Section 96(2) Modification SSD 6674 (MOD 1) Environmental Impact Statement

University of New South Wales

Biological Sciences Project - Stage 1

Submitted to Department of Planning & Environment
On Behalf of University of New South Wales

Figure 5 – Existing and proposed northern elevation of Building D26
Source: Woods Bagot + JBA

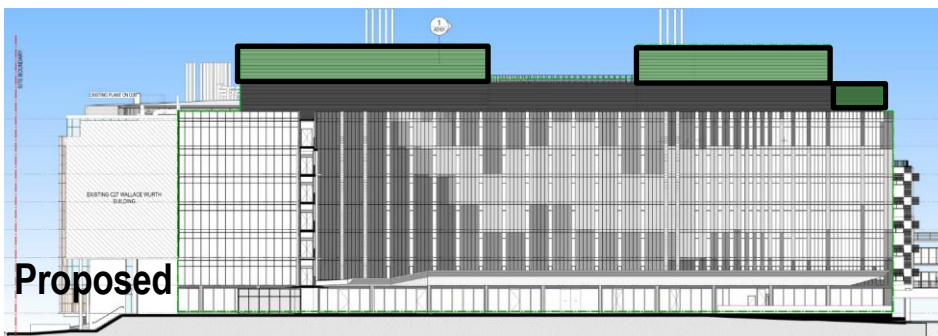
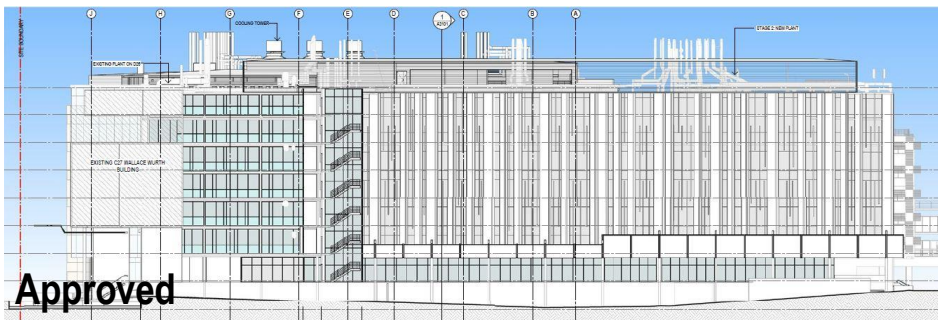
The proposal seeks to amend the height of roof top plant of D26 in sections of the rooftop, to provide for mechanical services for the uses in the building below. Whilst the plant located on Level 7 is to be expanded (as shown in Figure 5) the height of this plant level and the building parapet are not proposed to be amended. The building height comparison is provided in Table 1 and a comparison of the northern elevation provided in Figure 5.

Existing Approval	Proposal	Change
Building D26 – Building Height			
Top of Plant	RL 90.4	RL 96.2	5.8m (see Figure 5)

Additional plant + Building height shown in green

Figure 6 – Existing and proposed building envelope
 Source: Woods Bagot + JBA

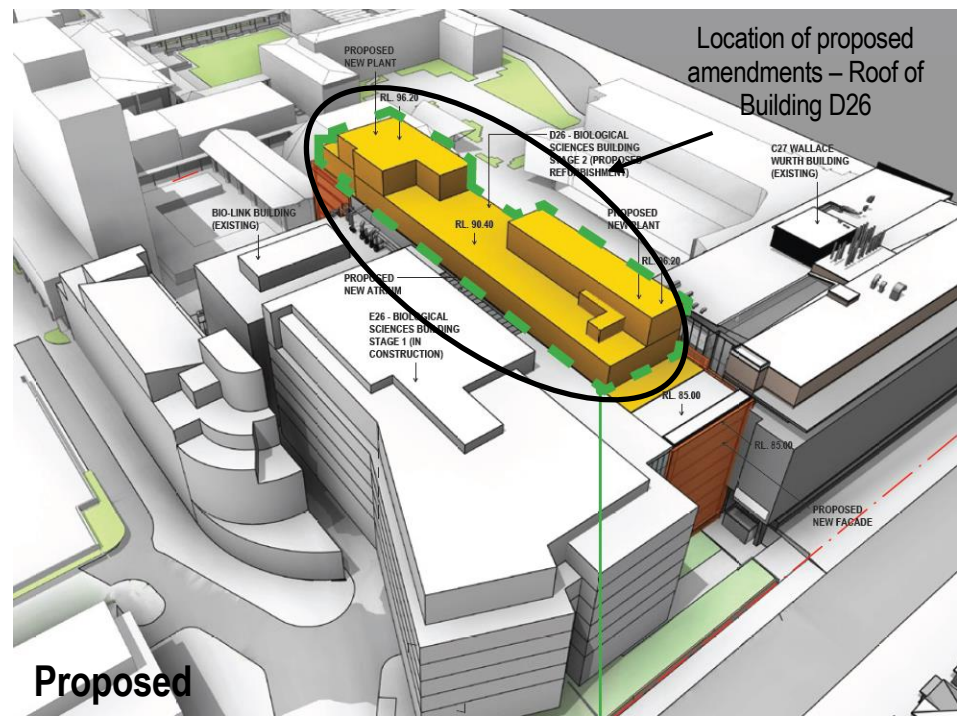
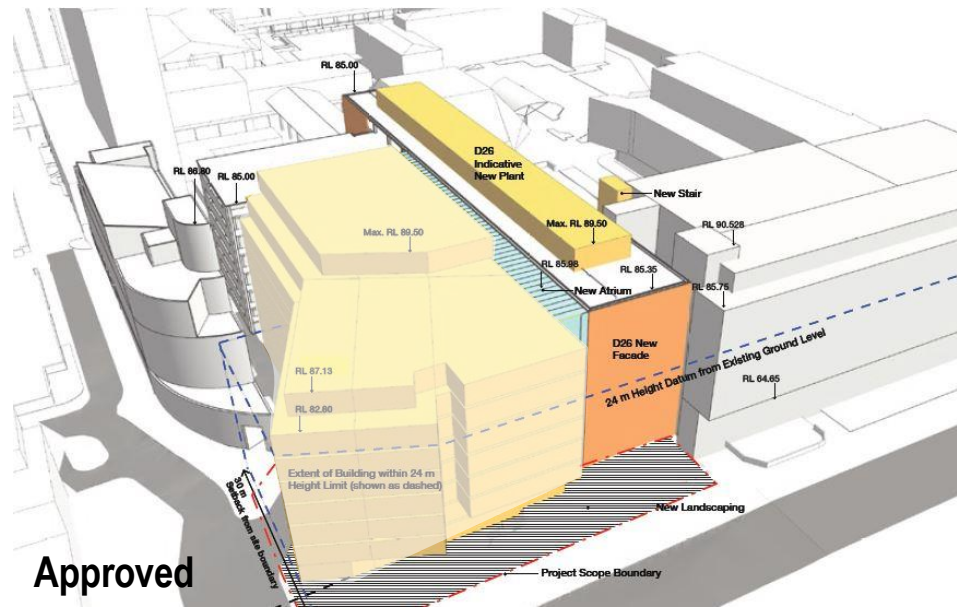
Level 7 (plant) now extends to generally align with the building façade below, whilst retaining a setback from Botany Street of approximately 30m. An additional plant level (level 8) is then located in two locations setback from the eastern and western building edges to minimise visual impact from key pedestrian routes and Botany Street in particular (see **Figure 6**). No change is proposed to the building envelope of design of Building E26.

A comparison of the existing and proposed building envelope is provided in **Figure 6**.

As shown in **Figure 5** and **6**, an additional level has also been added to parts of the roof enclosure in order to house fume cupboard exhaust fans, animal house exhaust fans, cooling tower enclosure, and an emergency generator. As shown in **Figure 9** and as detailed on the Architectural Plans at **Appendix B**, the plant will be screened with cladding.

Figure 7 – Existing and proposed ground floor plan
Source: Woods Bagot + JBA

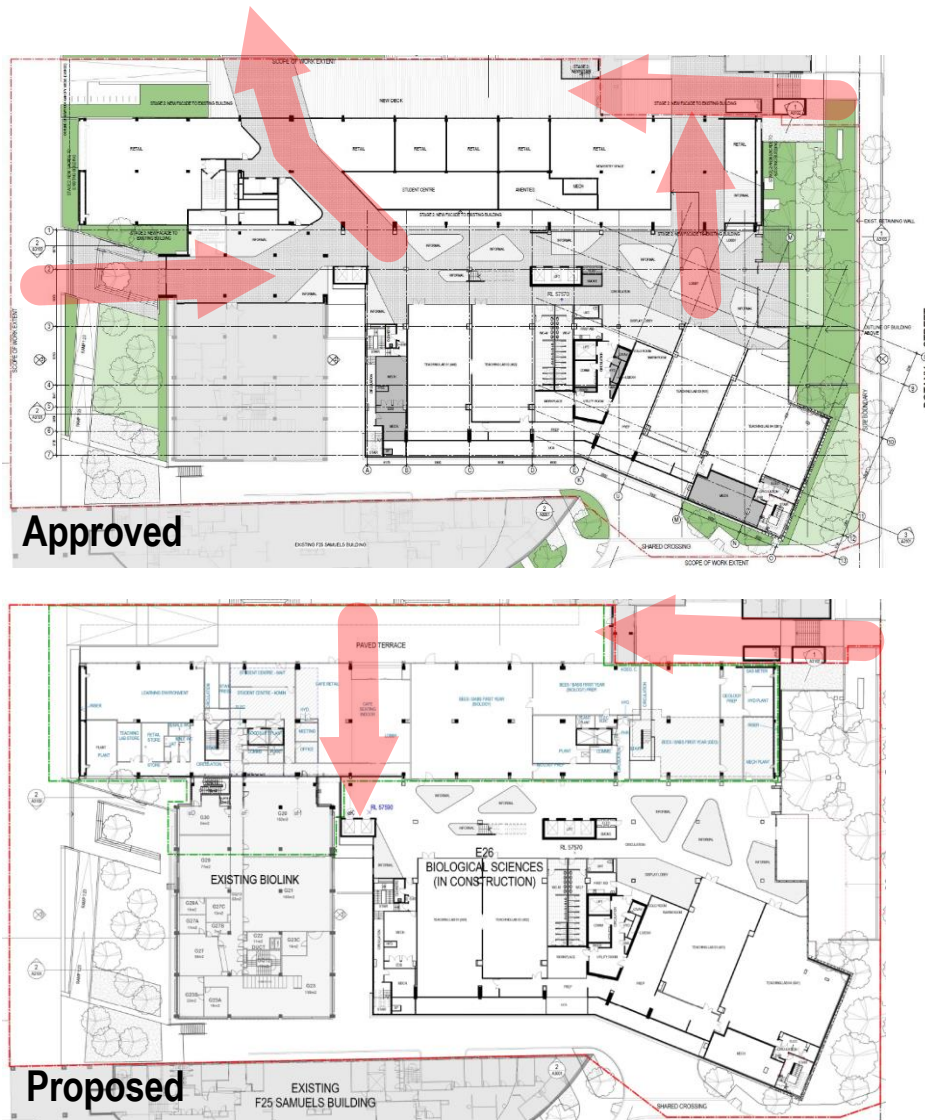
The proposed modifications to the ground floor seek to increase teaching and university spaces, resulting in a reduction of the retail spaces provided. The amendments also involve the relocation and reconfiguration of the geometry of the building entry from the north. This allows a more centralised location within the building, and to provide a more appropriate distribution of uses on either side of this entry.

As part of the ground floor modification the access from the D26 Building through to Wallace Wurth has been removed, to provide for a new geology laboratory space. Amendments have been made to the Biolink building to provide additional teaching spaces.

The teaching and laboratory spaces proposed on the Ground Floor were previously allowed for on the upper floors of the D26 Building. The removal of retail uses and reconfiguration of the building entry has allowed for this space to be better distributed through the building on the Ground Floor.

Figure 8 – Tree removal plan
Source: Birds Tree Consultancy

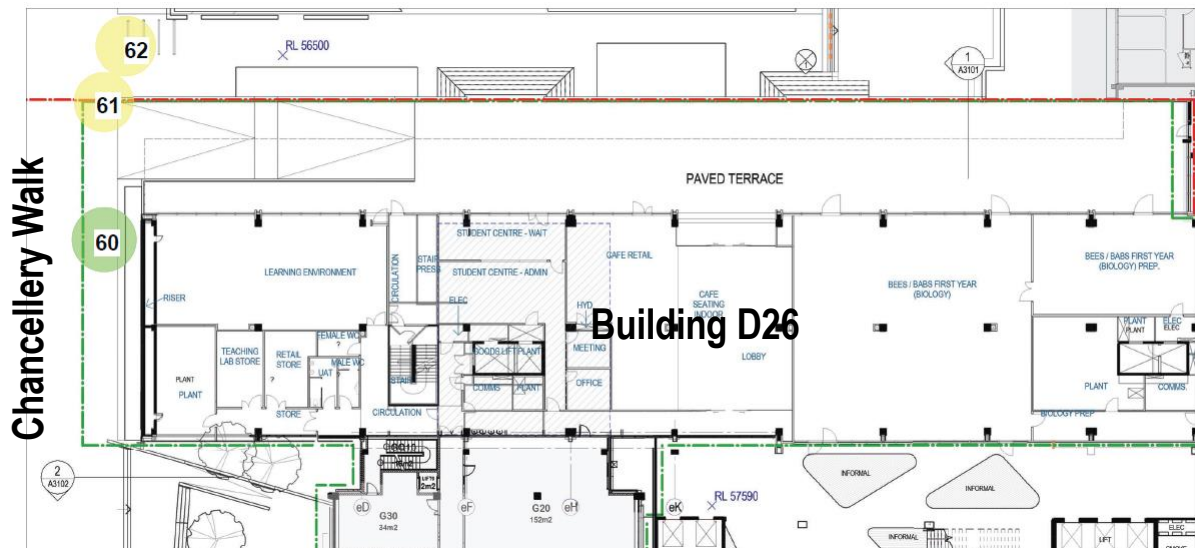
Given the modification proposed to the Ground Floor Level, particularly in the north-western corner of the site, two additional existing trees will be affected. A revised Arboricultural Assessment (**Appendix N**) has been prepared for this application and considers the additional impact proposed (see **Section 6.10**). The additional trees affected as part of this modification are identified as tree 61 and 62 at **Appendix N** and consist of two cabbage tree palms. Tree 60 is proposed to be retained.

The key difference between the original approval and proposed modification is the impact to Tree 61 and 62 (cabbage tree palms) that are affected because of extending the access ramp further west than the original approval. These trees are suitable for transplantation.

Figure 9 – Existing and proposed building section (north/south section)
Source: Woods Bagot

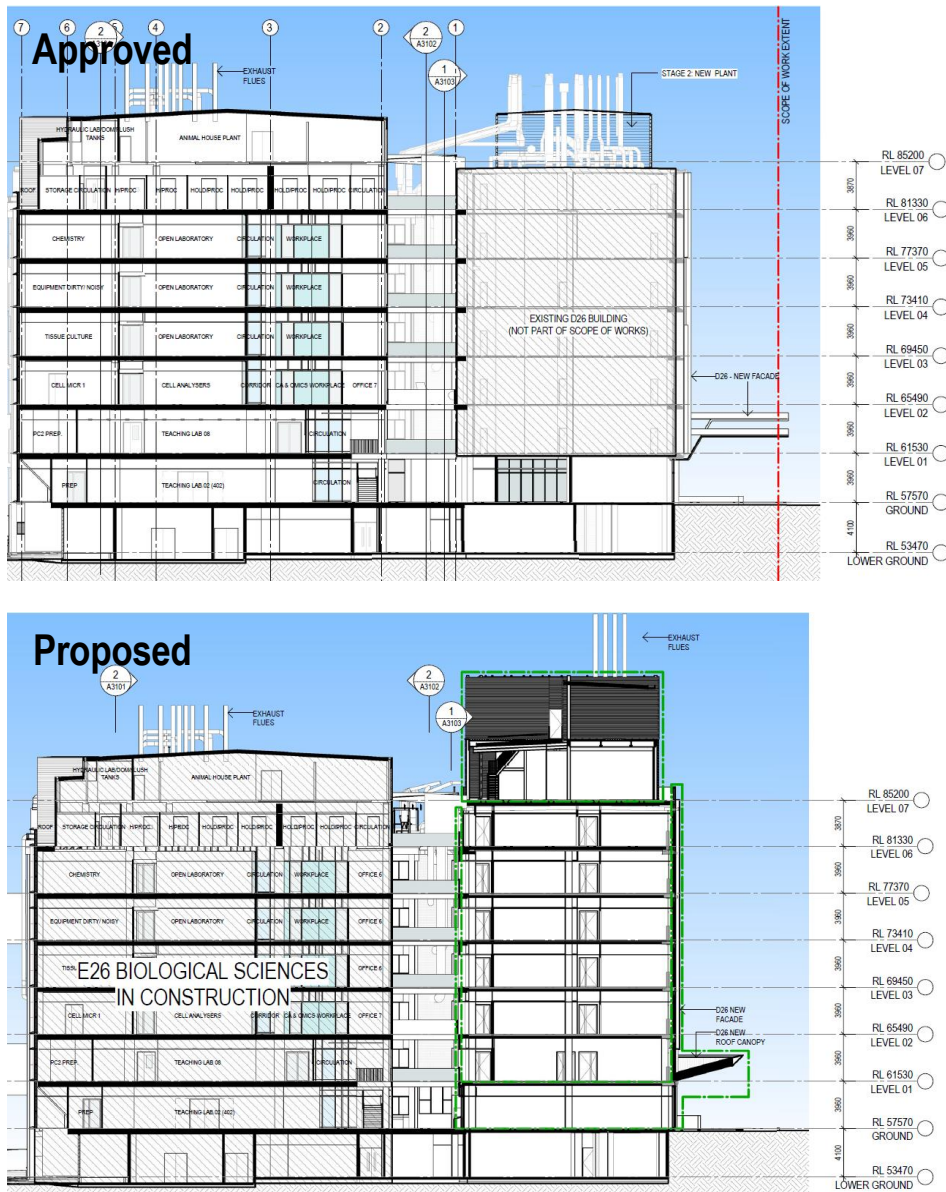
As noted above, the building height and roof top form is proposed to be modified in order to accommodate additional plant required to service the buildings. As shown in **Figure 9**, an animal house has been added to Building D26 on Level 6 (subject of the concurrent SSD application), that has resulted in the plant being raised to level 7.

Due to the additional requirements of the buildings below the plant of this level is extended to be closer to the parapet of the building below on all elevations with the exception of the eastern elevation to Botany Street, maintaining a 30m setback from the boundary.

Figure 15 – Roof Plan
 Source: Woods Bagot + JBA

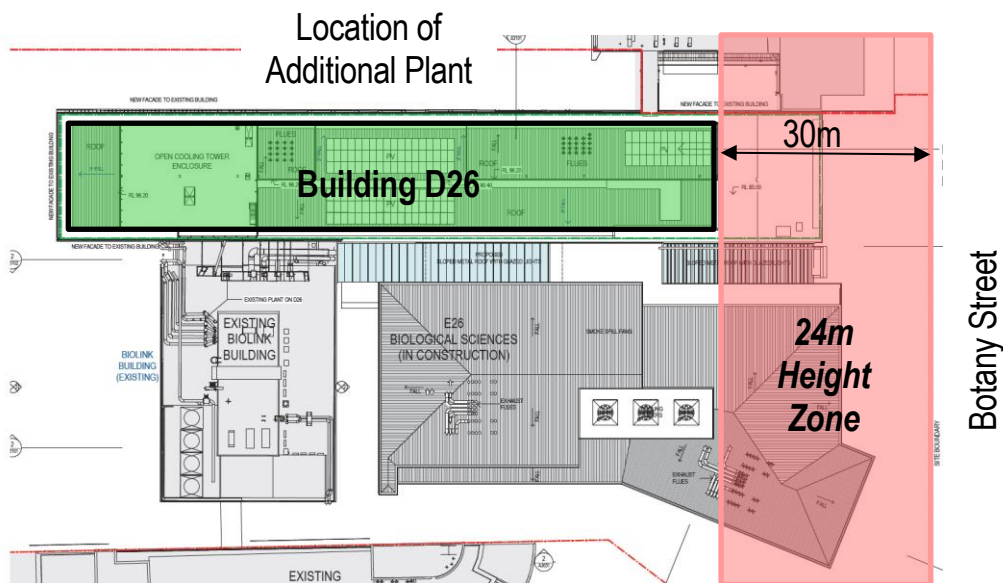
Whilst a Clause 4.6 variation request was submitted with the original SSD application, the modification proposed in this S96 application do not seek to vary the building height within the permitter building height zone. The building height that results from additional/reconfigured plant and equipment to the rooftop is located within the Campus and is not located within the 30m wide 24m permitter height control as shown in Figure 145
